# DNM Pre-Amplifier upgrade, for 3D and 3C/3B

Second generation volume control  
new front panel switch functions

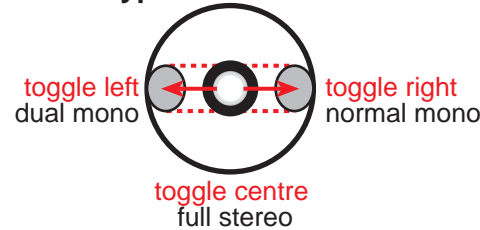
**vertical movement 3 position switch**  
changes volume control rotation  
for a required sound level

**horizontal movement 3 position switch**  
gives two types of mono or full stereo

**Dual Mono**

Both channels fully combined giving identical left/right signal. Both volume controls must be set to exactly the same level.

**Normal Mono**

Both channels well combined allowing left only or right only or both volume controls to be used.
